LB/230817 / LLFA Letter / SCP Response
28 October 2025

Planning Reference – 139751/FO/2024

SCP Technical Response to Manchester City Council Planning Condition [PC27] Drainage

LIDL FALLOWFIELD

PROPOSED SITE PLAN

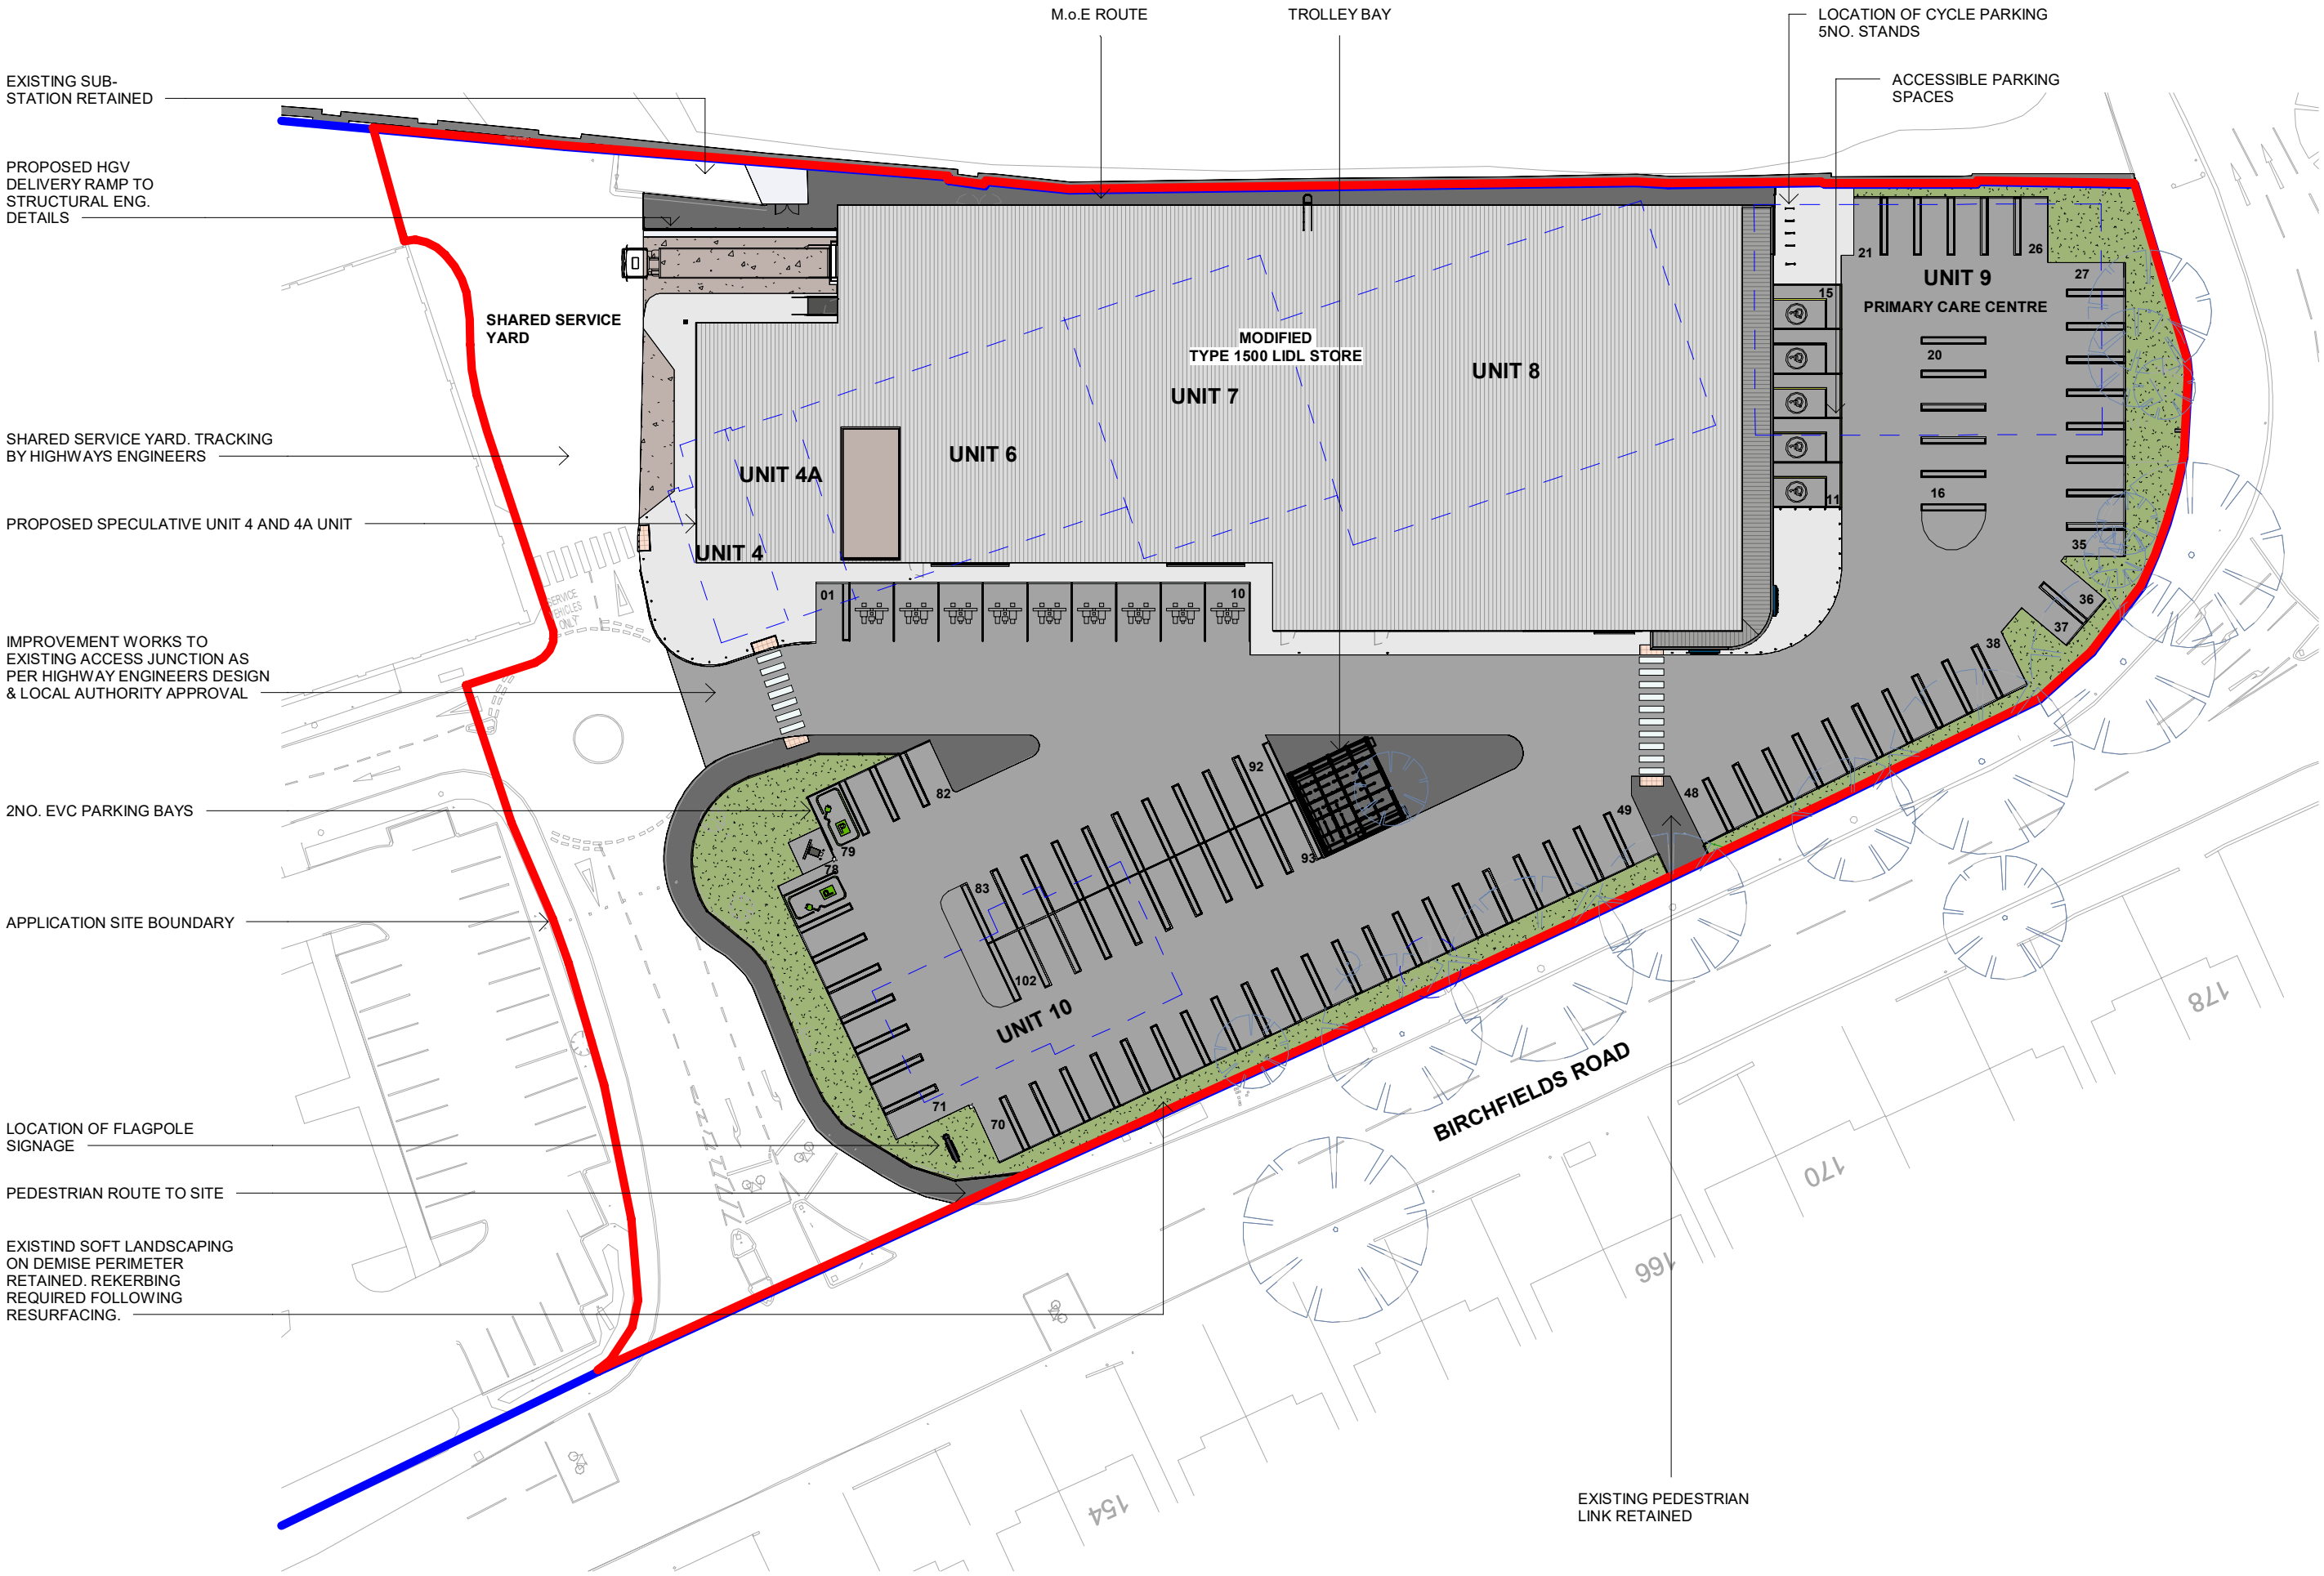
3	<i>Flooding is predicted in the 1 in 100 and 1 in 100+45%CC scenarios. Currently flood volumes have been hand-written onto a drainage layout, and general areas highlighted yellow. Also required is clarification as to whether a larger tank could be utilised to prevent predicted flooding at the 1 in 100 and 1 in 100+45%CC events and demarcation of the predicted flood volumes from all manholes and the modelled/mapped rote of this predicted flooding onto a drainage layout or the overland flow route plan, supported by mapped site levels.</i>	<p>National and local standards are:</p> <ul style="list-style-type: none"> • 30 years – no flooding allowed • 100 years – flooding is allowed as long as no flooding of buildings or leaving site • 100 years +45%CC – flooding is allowed as long as no flooding of buildings or leaving site <p>Therefore, our modelling is compliant against national and local polices for modelling and flooding compliance.</p> <p>Our 100 years +45%CC shows 15m3 of flooding at manhole 1, located around the back of the Lidl store.</p> <p>The existing site has a large brick wall, which is being retained and will act as a barrier to stop flood water actively leaving the site and at this location the store building has no</p>

<p>door opens. [Refer to Appendix B external works drawing 2004-A3-C3.</p> <p>The below image from Google Maps shows the existing brick wall along the back of the site boundary.</p>  <p>Please also refer to the Appendix C for proposed overland flows drawing (200509-0500-004) showing the location of MH01</p> <p>Therefore, no flooding of the new building or leaving site would occur.</p>
4	<p><i>Site-specific cross-section construction details drawing of the proposed attenuation tank, including levels, dimensions etc.</i></p>	<p>We have attached the Lidl base specification typical tank detail LD(14)-SP-06, see Appendix D.</p>
5	<p><i>The applicant must present a consistent package to discharge this condition (including all layouts and calculations). The layout and calculations must be jointly updated to account for any edits required. When preparing a resubmission, the applicant must ensure that the drainage layout and hydraulic calculations correspond, and that they can be cross-referenced for checks. This includes layout annotations and schedule printouts.</i></p>	<p>It is acknowledged that the pipe numbers that are in the drainage modelling report are not shown on the drainage strategy layout [due to the strategy coming first, then the modelling report second], and that on the drainage strategy the pipe sizes are 225mm and the developed hydraulic modelling shows these at 300mm to remove throttle and utilise the capacity identified in the storage tank.</p> <p>This is to be captured and updated on the internal drainage detailed design, by the Lidl appointed consultant for the internal drainage design tender package.</p>

Drawing Title:			
PROPOSED OVERLAND FLOWS			
Date:	20.05.2025	Drawn By:	HG
Scale:	1:250@ A1	Checked:	AI
Status:	DETAILED DESIGN	Approved:	UNAPPROVED

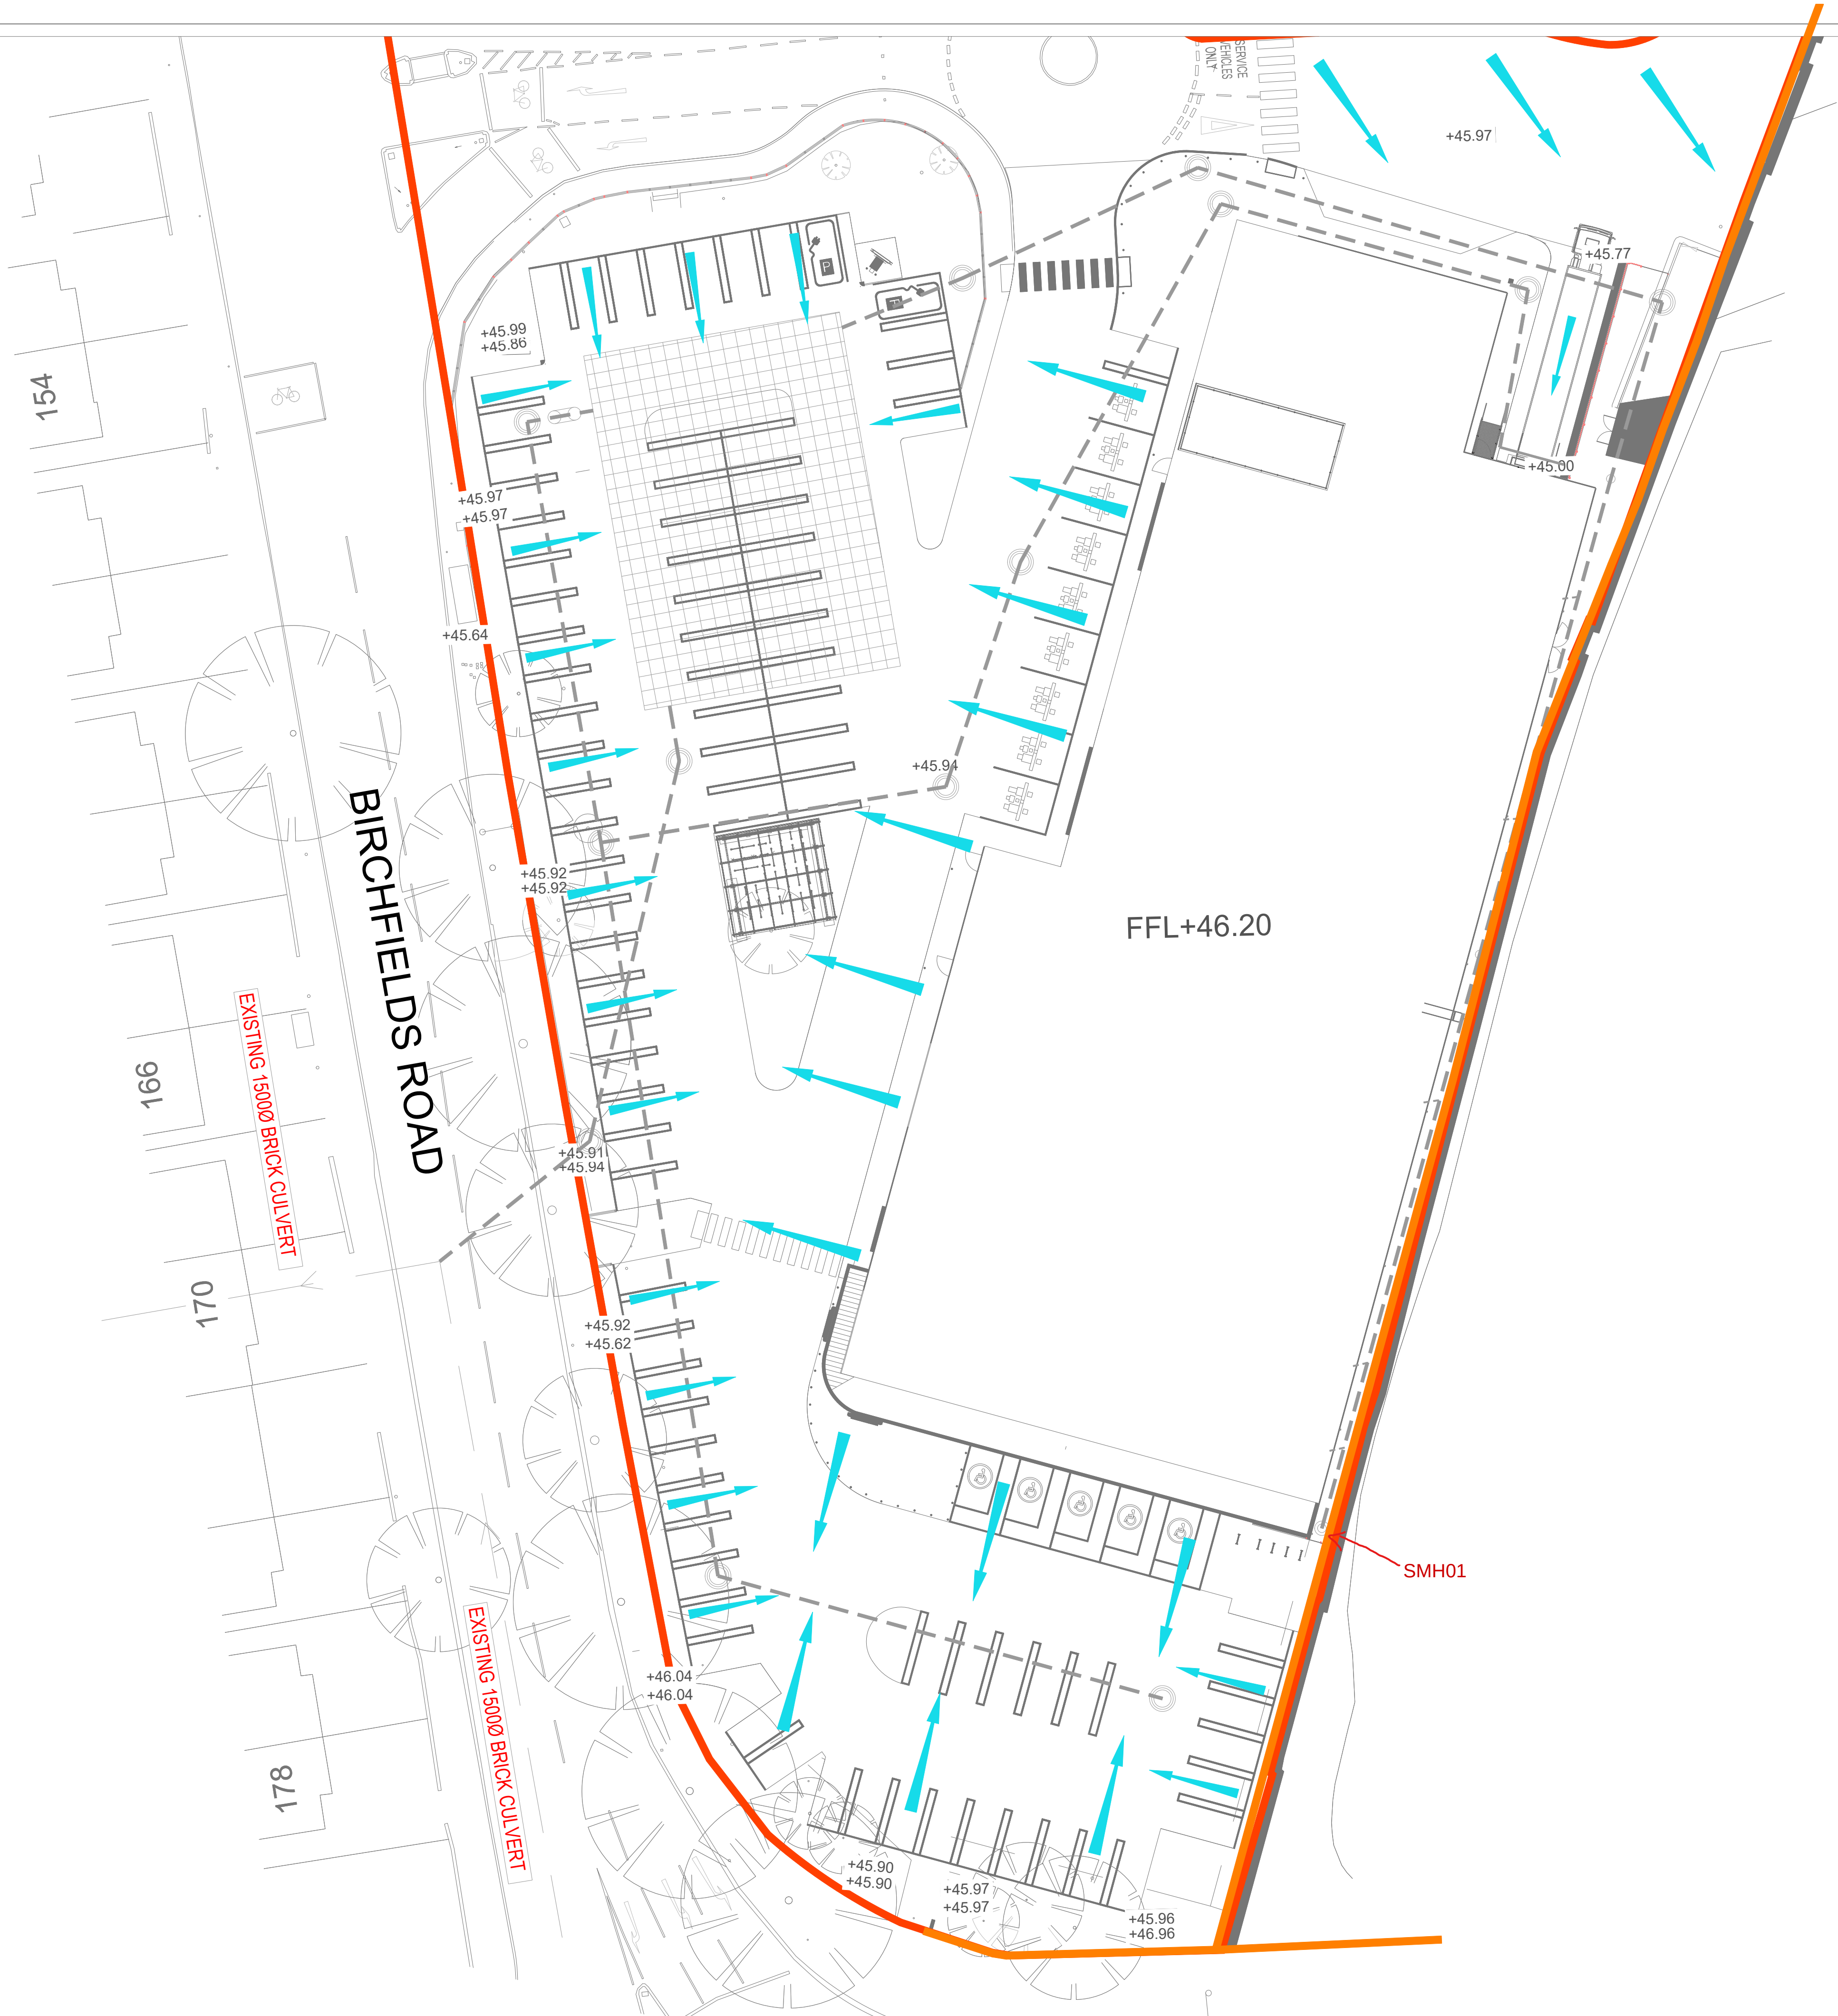
-Flooding is predicted in the 1 in 100 and 1 in 100+45%CC scenarios. Currently flood volumes have been hand-written onto a drainage layout, and general areas highlighted yellow. Also required is clarification as to whether a larger tank could be utilised to prevent predicted flooding at the 1 in 100 and 1 in 100+45%CC events and demarcation of the predicted flood volumes from all manholes and the modelled/mapped route of this

predicted flooding onto a drainage layout or the overland flow route plan, supported by mapped site levels.

TYPICAL ATTENUATION TANK SECTION

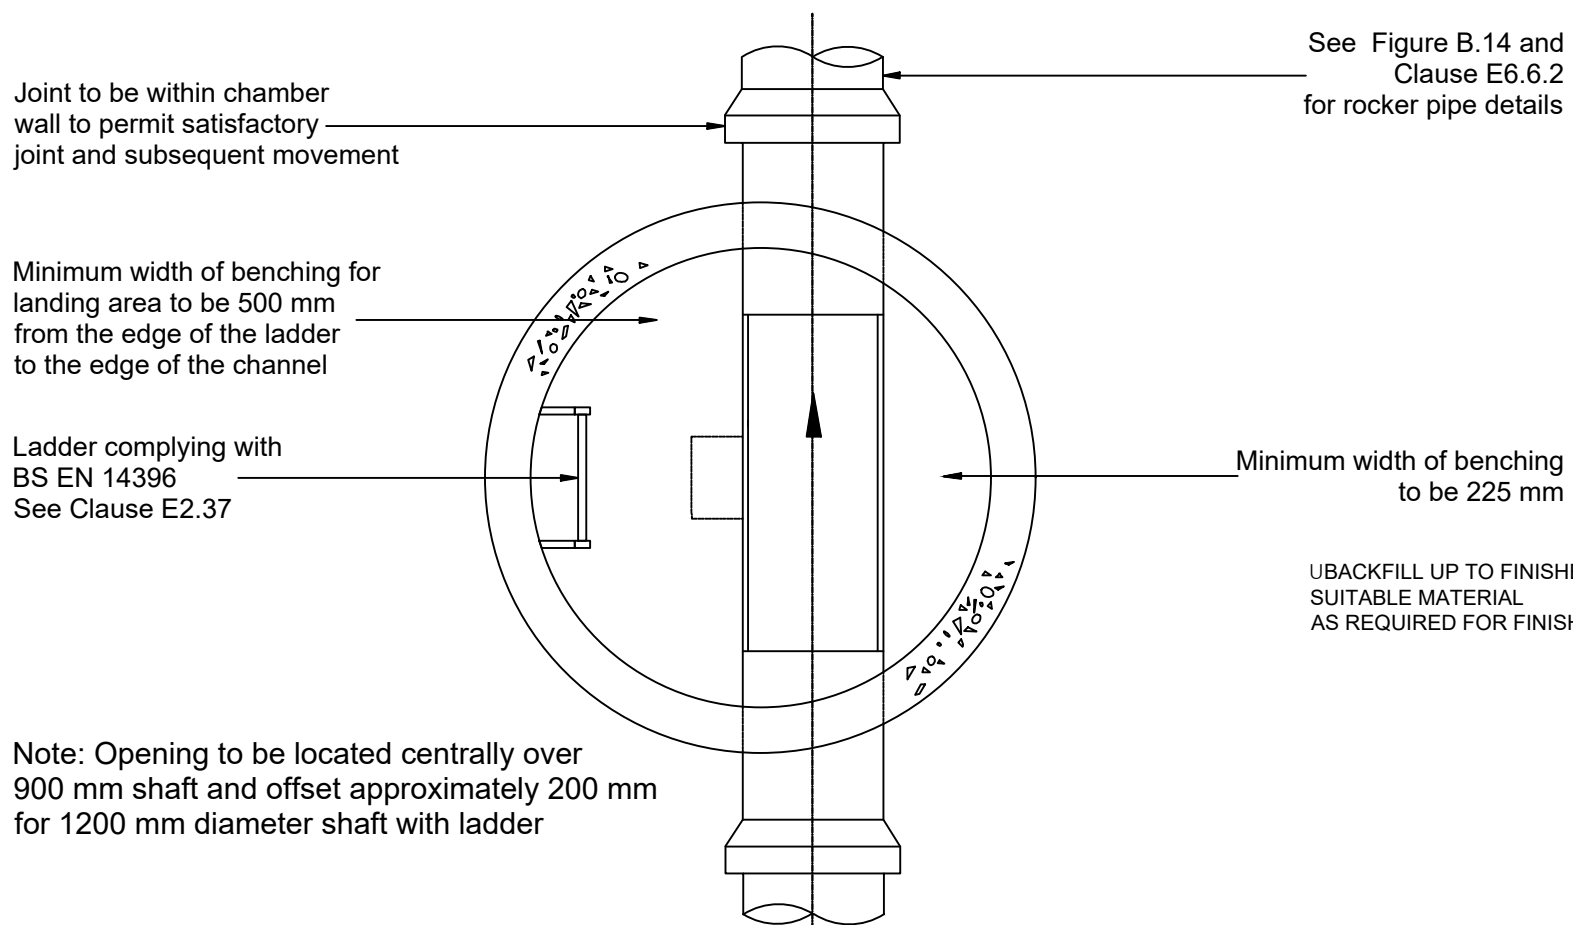
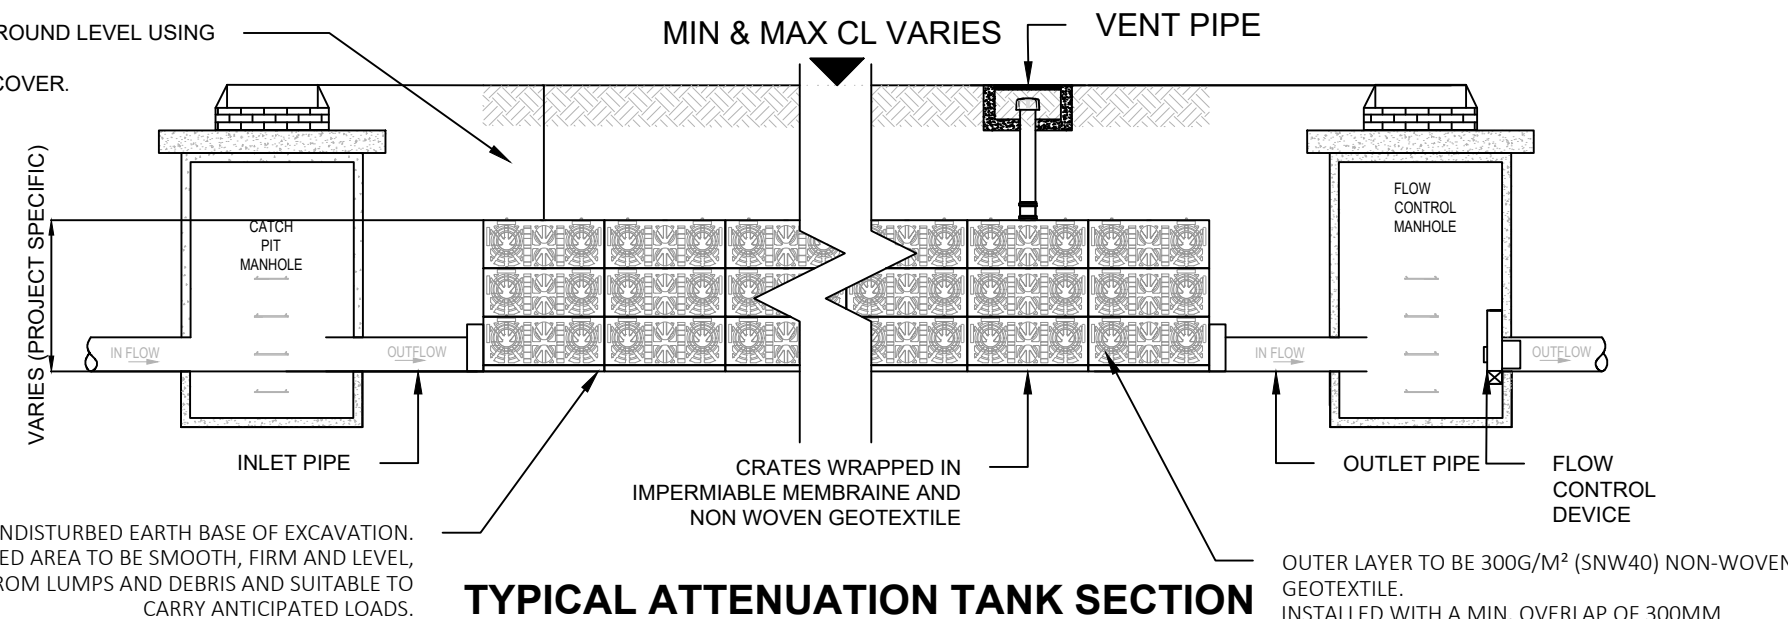
-Site-specific cross-section construction details drawing of the proposed attenuation tank, including levels, dimensions etc.

1. For the 1 year, 2 year, 30 year storm and 100 year + 45% CC events the Micro-drainage hydraulic simulation results show that the Lidl Fallowfield proposed storage tank is suitably sized to provide storage for the site and allow for a 4.78l/s discharge rate in line with the greenfield run off rate.
2. SuDS measures have been proposed including a petrol interceptor and catchpits to remove sediment and fluids other than water prior discharge into existing watercourse.
3. Overland flood flow route analysis has been undertaken to show that flooding does not affect the Lidl store and can be effectively managed.
4. Tank cross sections and construction details attached.
5. Hydraulic modelling and drainage design to be co-ordinated at detailed drainage design.
